Freemasons Hall Manchester

Planning Application Addendum in response to comments received on 24th May

24th October 2013

Aedas

Fig 08 Extract from Photographic Record Location Plan

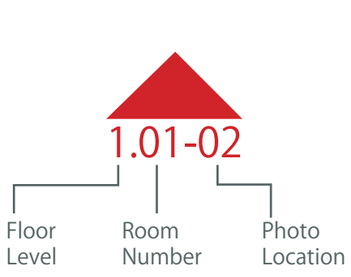
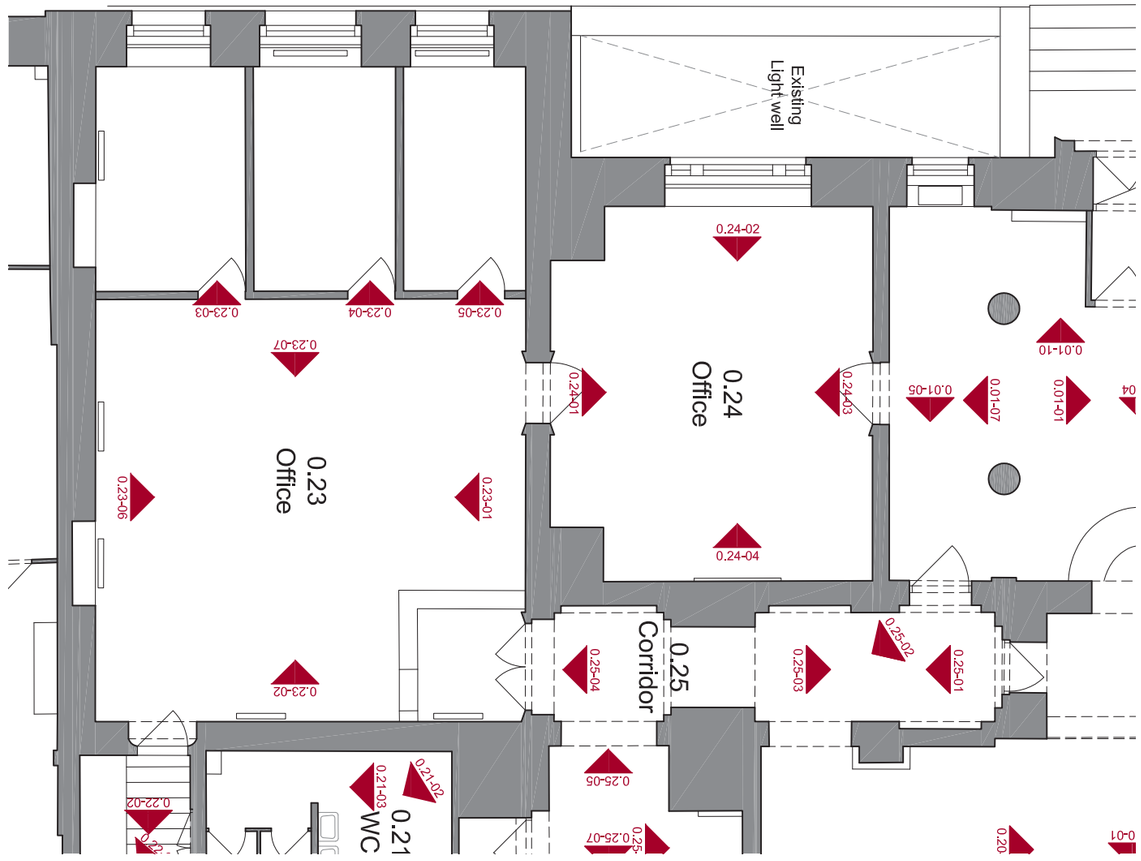
9.1 A comprehensive set of photos of all affected rooms and elevations is required.

9.1 Please find attached photographic record of all rooms affected by the proposed works. In addition, please find attached reference plans illustrating the locations of each photo

For clarity, the photographs have been placed in folders that are named to match the room numbers on the attached plans. Each photos has been named to relate to the location markers on the plans.

Fig 11 Existing interior in Starkie Dining Room

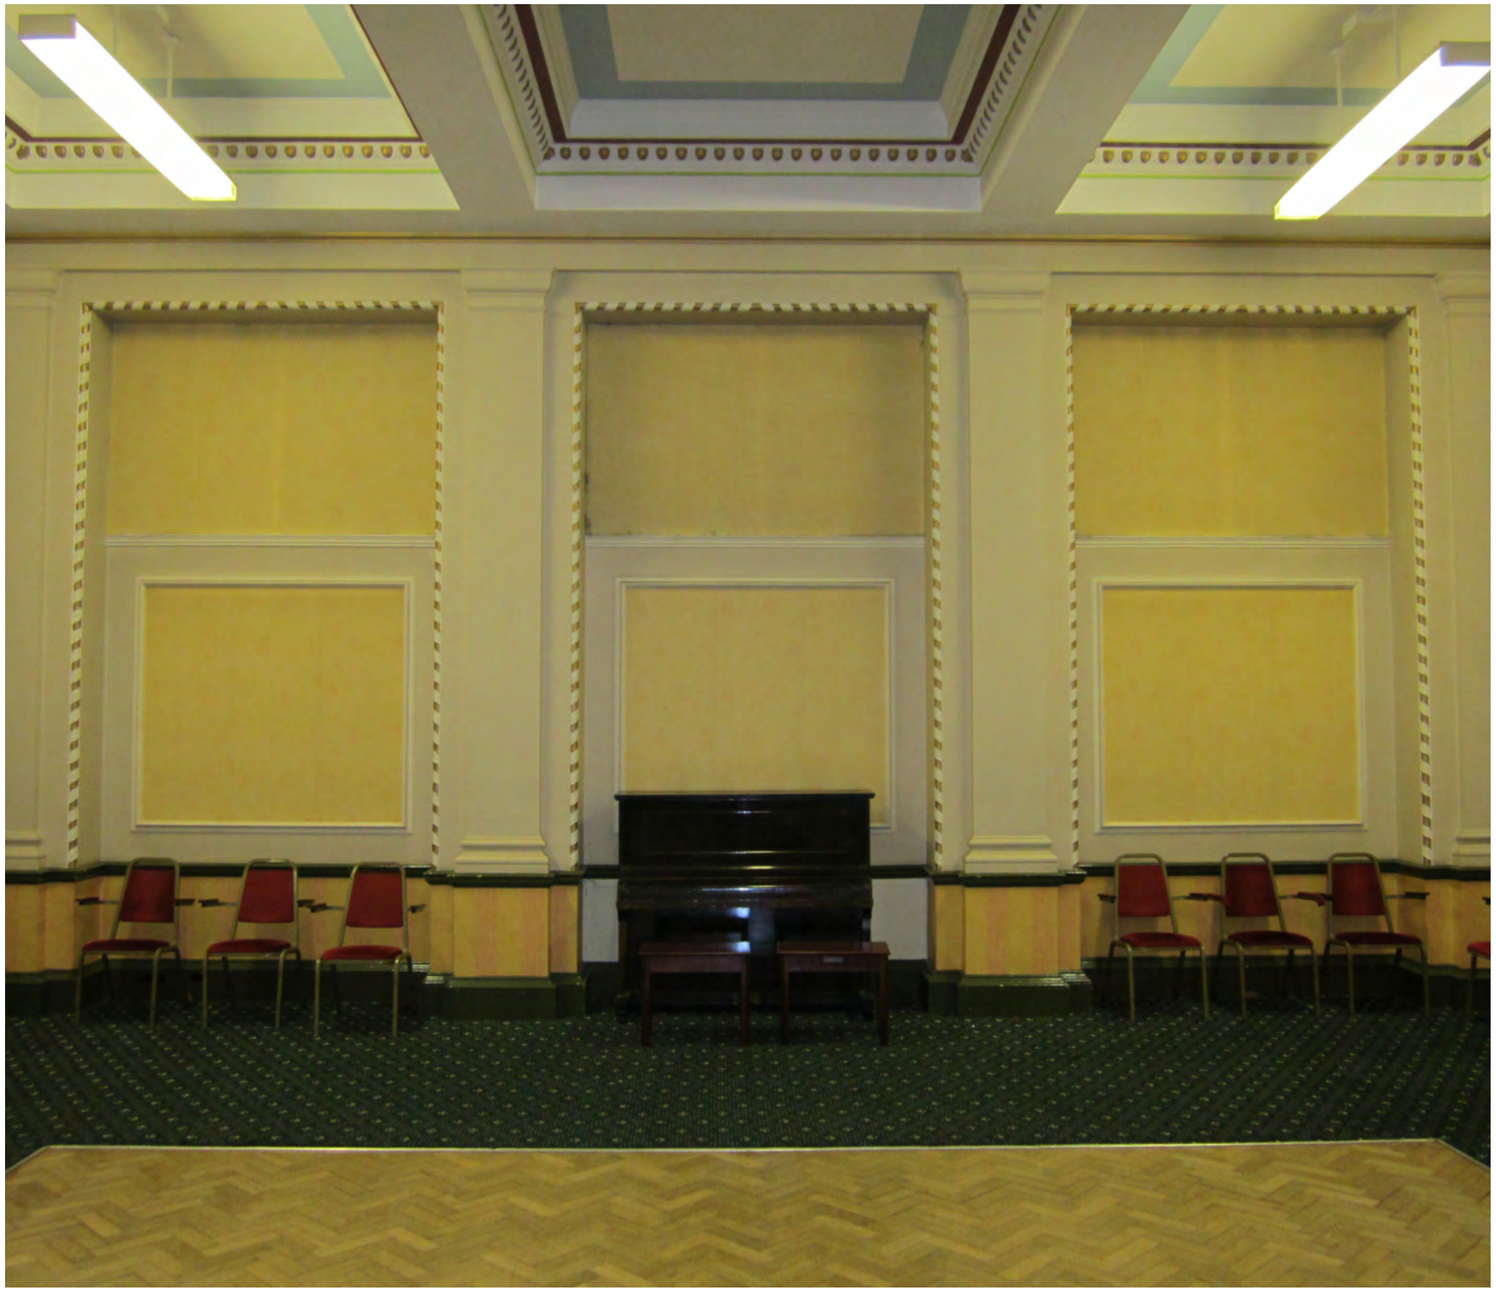
12.1 Detailed sections and details or making good openings required for opening up of windows in basement Starkie Room

12.1 The original window openings within the Starkie Dining Room have been blocked up. The original existing frames are still in place externally. Our proposals look to reinstate these windows to allow much needed daylight into this basement room.

Please find attached drawing PL(00)076 which illustrates this intervention in further detail.

Fig 14 Proposed Roof Plan

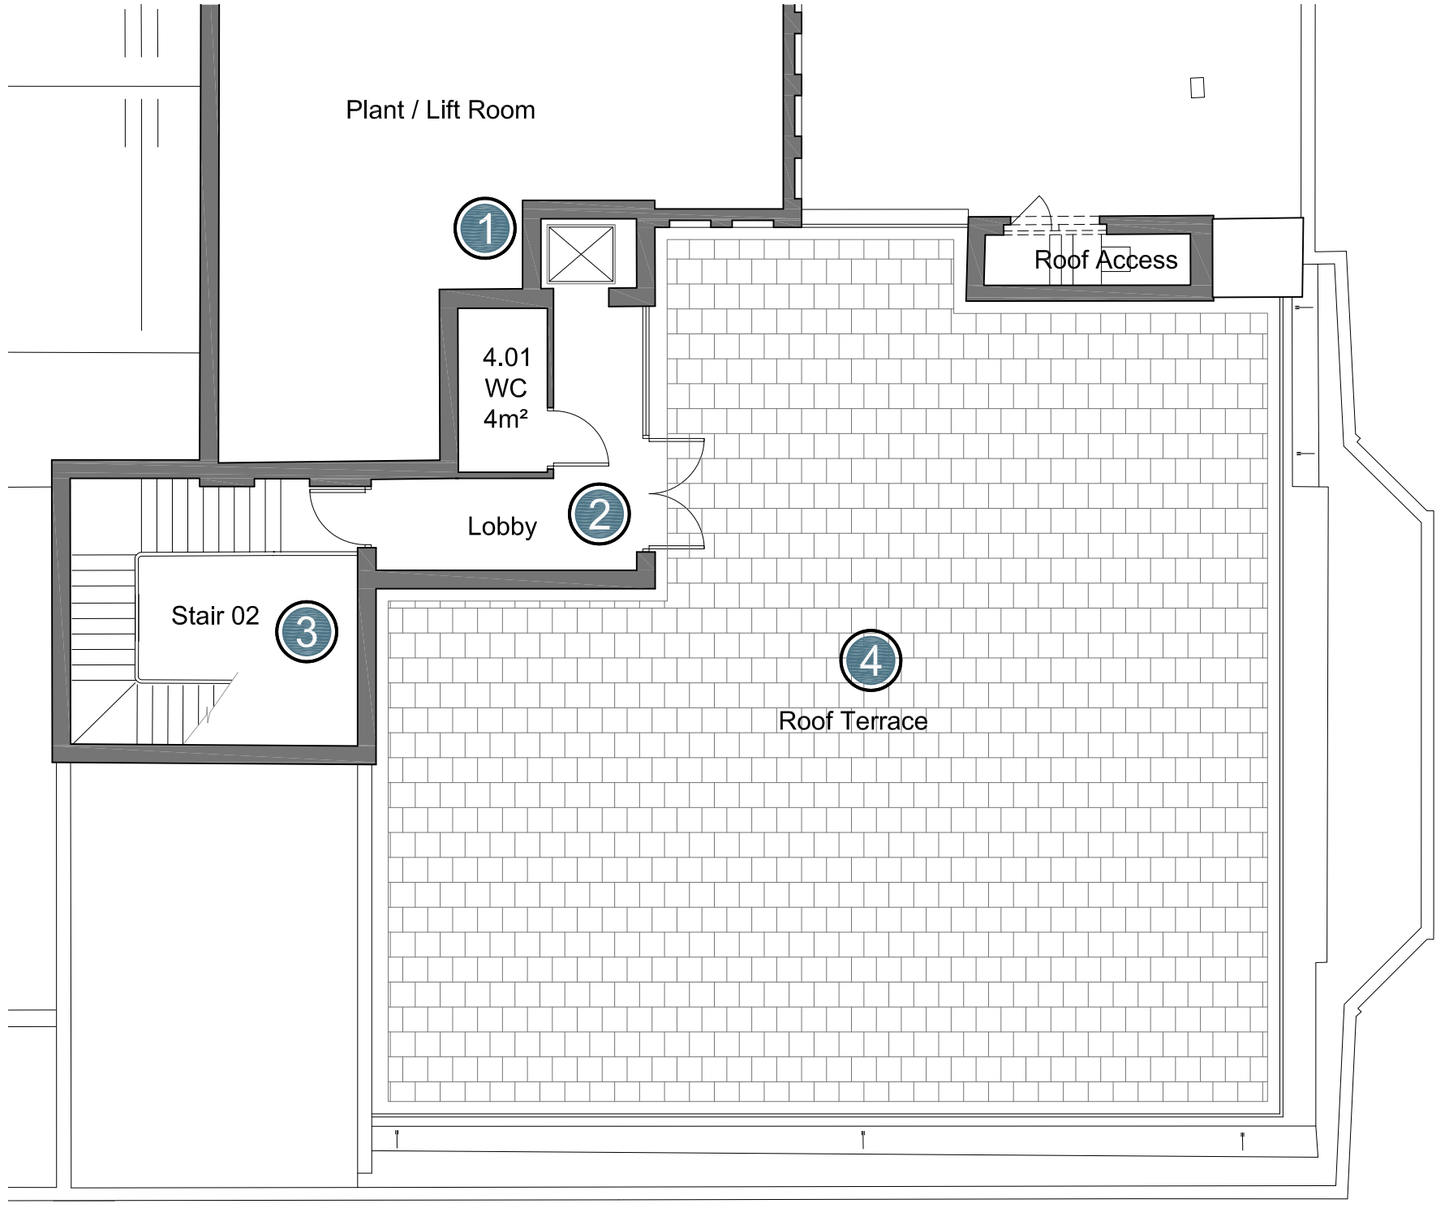
15.1 Details required to illustrate balustrade and self arrest system.

15.1 Please find attached drawing PL(00)075 illustrating the balustrade and self arrest systems proposed to the roof top terrace area.

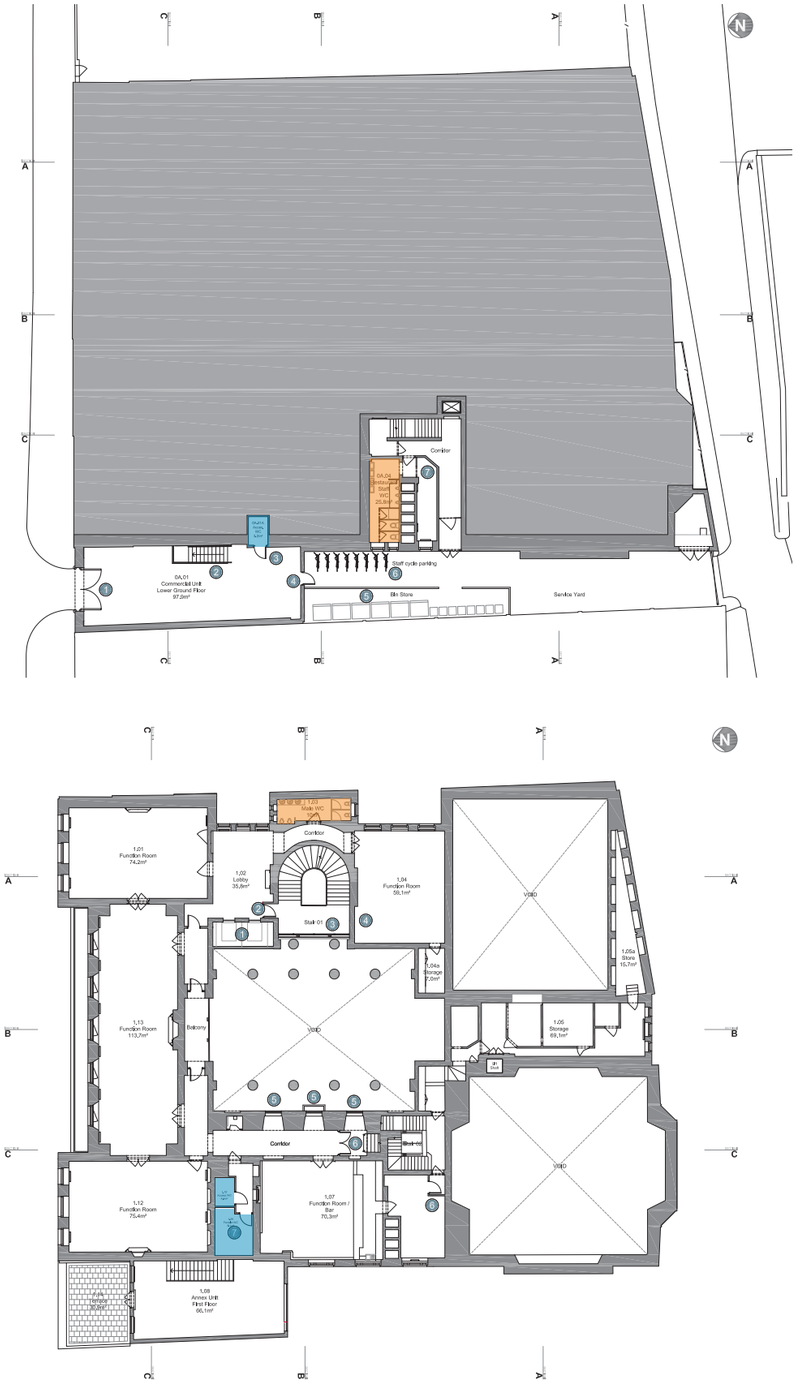
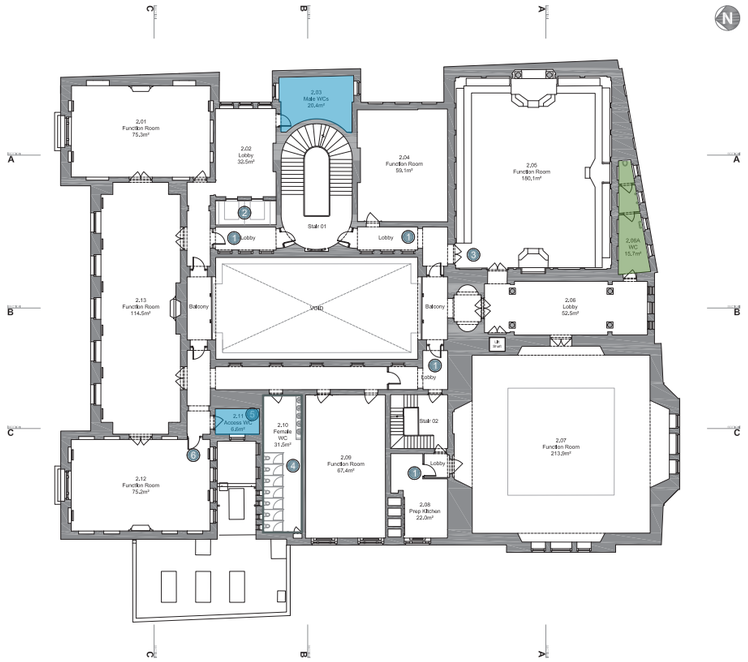
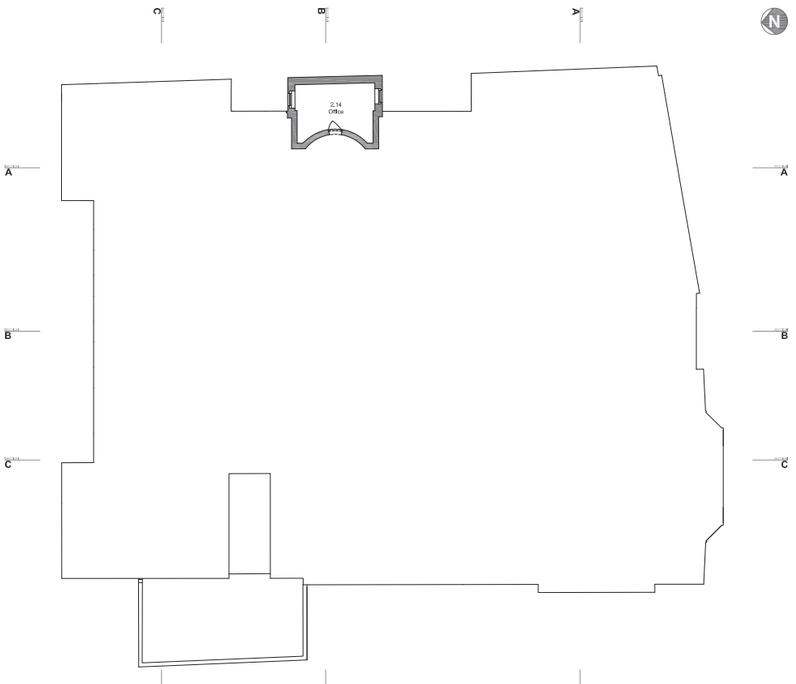
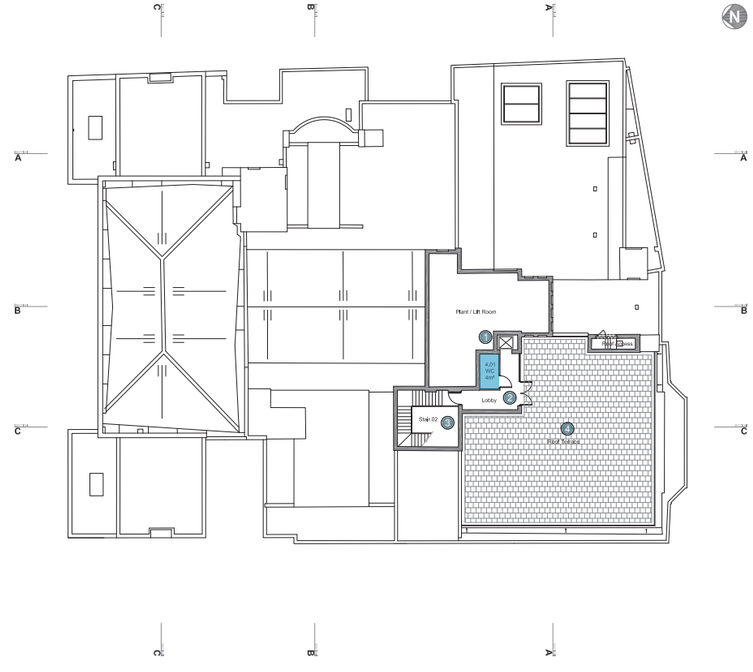
18.1 Overview required of where these are being retained and / or refurbished

18.1 Please find following diagrams illustrating the location of all sanitary provision highlighting where these are been retained , refurbished, or where there is new provision.
